**Reviewed as
Modified**
exp Services Inc.
January 11, 2016
P.Vegh

REVIEWED ()
REVIEWED AS NOTED (X)
REVISE AND RESUBMIT ()
NOT REVIEWED ()
DATE: 2015-12-04
REVIEWED BY: TC

SQ ALEXANDRA PARK CONDOMINIUMS

SHOP DRAWINGS FOR ALUMINUM
BALCONY AND TERRACE RAILINGS
OCTOBER 8, 2015

BALCONY & TERRACE RAILING POST LAYOUT 13th FLOOR PLAN
 SCALE 1:275

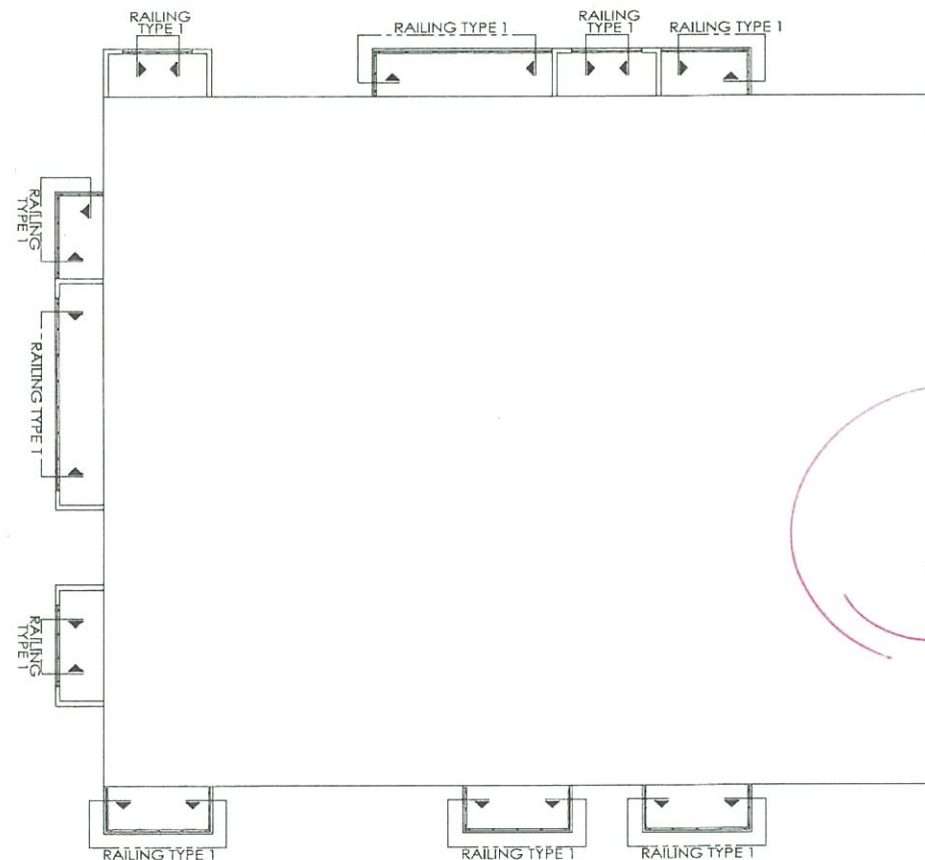
SLAB COVER PANELS
STILL REQUIRED HERE;
GLASS GUARD ABOVE
CAN BE DELETED;
DETAIL SIMILAR TO
BALCONY RAILING SECTION
TYPE 1 BUT WITHOUT
GLASS GUARD PORTION.

2
23 TYPE 2 RAILING AT CURVED SLAB
DETAIL A-1

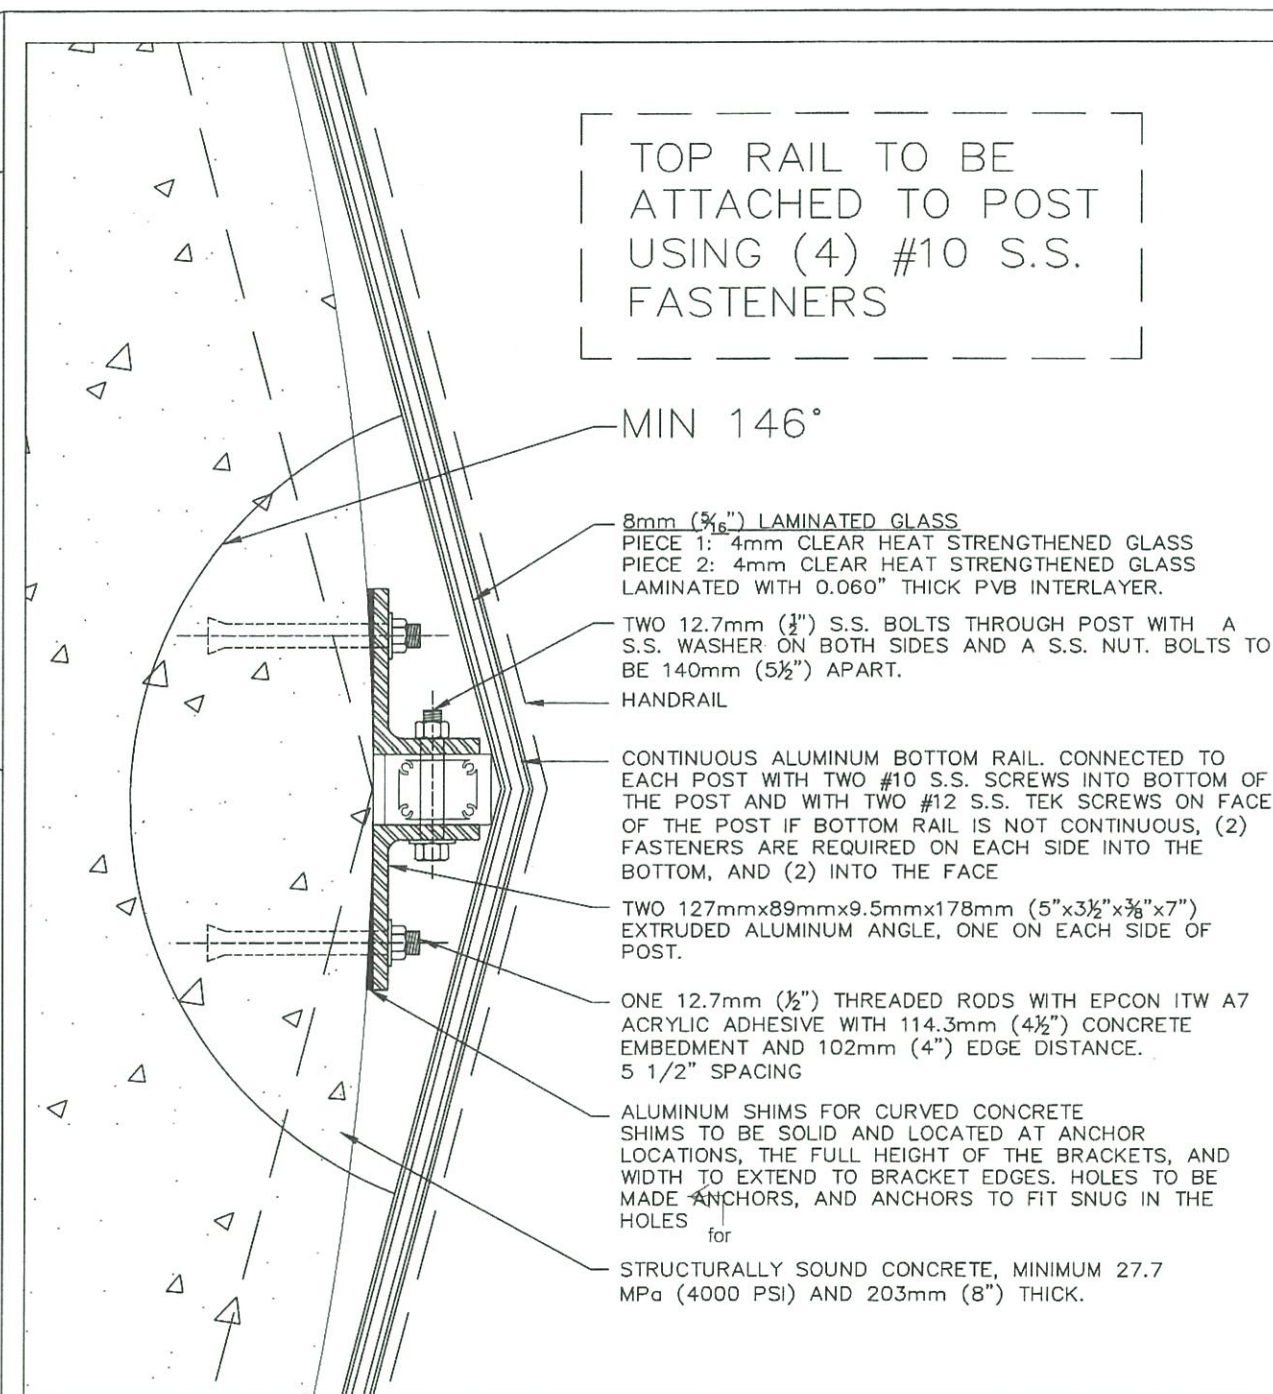
Ensure that glass can't touch slab edge when deflecting under max service load.

3
24 DETAIL A-2 NTS

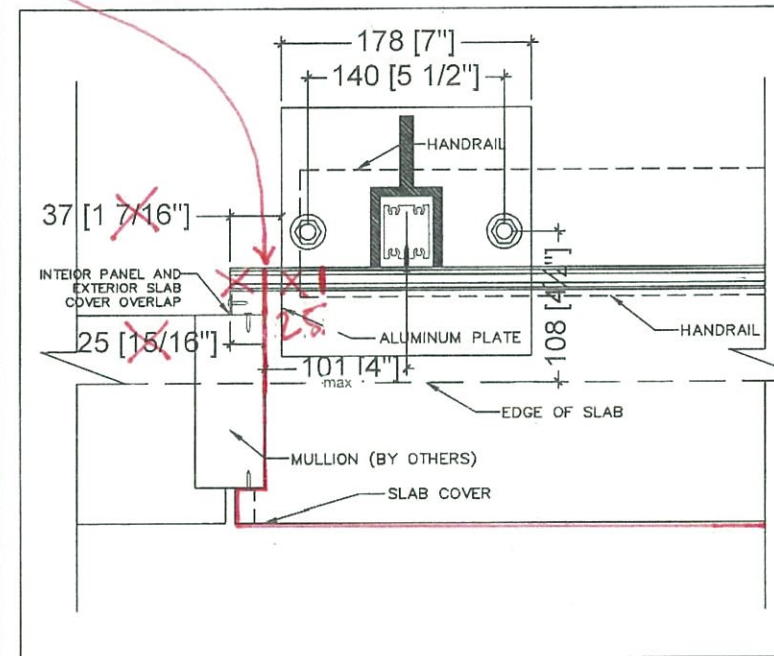
DETAIL 3/24 SUBMITTED PREVIOUSLY WAS CORRECT. ALIGN SLAB COVER WITH EDGE OF MULLION. ALLOW 25mm GAP BETWEEN MULLION AND RAILING/GLASS/ BOTTOM RAIL SYSTEM.
